AGENDA
FOR THE CITY OF OLIVETTE
PLANNING AND COMMUNITY DESIGN COMMISSION
MEETING OF MAY 26, 2016
AT 7:00 PM
IN THE OLIVETTE CITY COUNCIL CHAMBERS
AT CITY HALL GOVERNMENT CENTER
LOCATED AT 9473 OLIVE BOULEVARD

DATE: MAY 26, 2016
TO: PLANNING AND COMMUNITY DESIGN COMMISSION
FROM: CARLOS TREJO, AICP
 DIRECTOR OF PLANNING AND COMMUNITY DEVELOPMENT
RE: 9601 ASHMONT DRIVE
 PETITION FOR COMMUNITY DESIGN REVIEW, SITE PLAN REVIEW, CONCEPT STORMWATER
 MANANGEMENT REVIEW

RE: 9601 ASHMONT DRIVE
PRELIMINARY STAFF REVIEW OF PETITION FOR COMMUNITY DESIGN REVIEW, SITE
PLAN REVIEW, AND STORMWATER CONCEPTUAL REVIEW

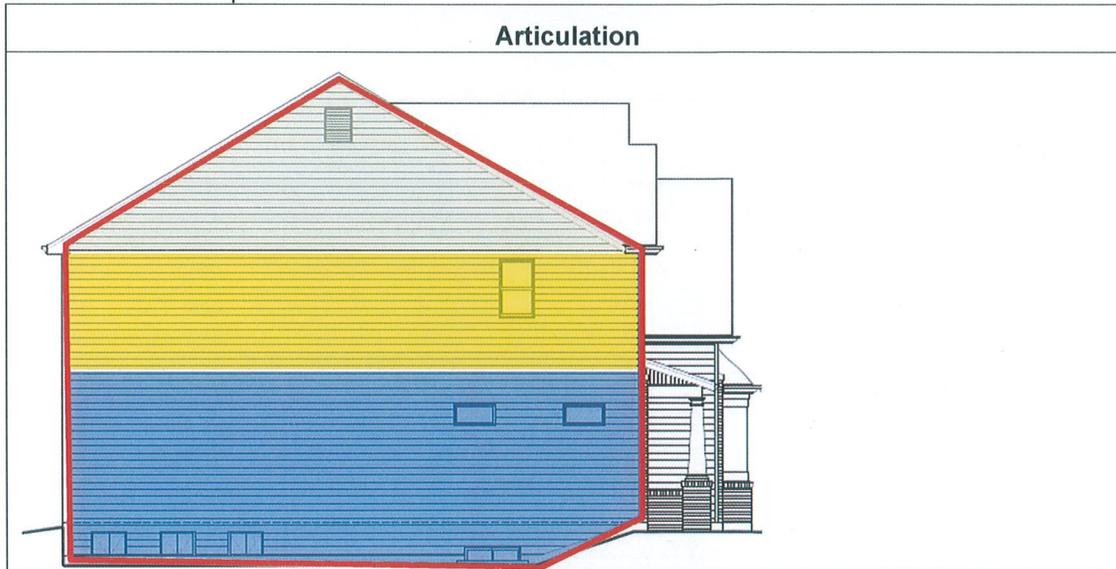
The home to the immediate west is a one story home. The proposed drawings do not illustrate transitional breaks between levels, or provide a significant break in the west wall elevation. This may be accomplished through the use of various materials, roof line, and breaks in the massing.

The shade represent three areas with similar flat breaks in the massing. The building plans illustrate a one-dimensional side elevation. Considerations should be given to break up the floor levels to decrease the void space.
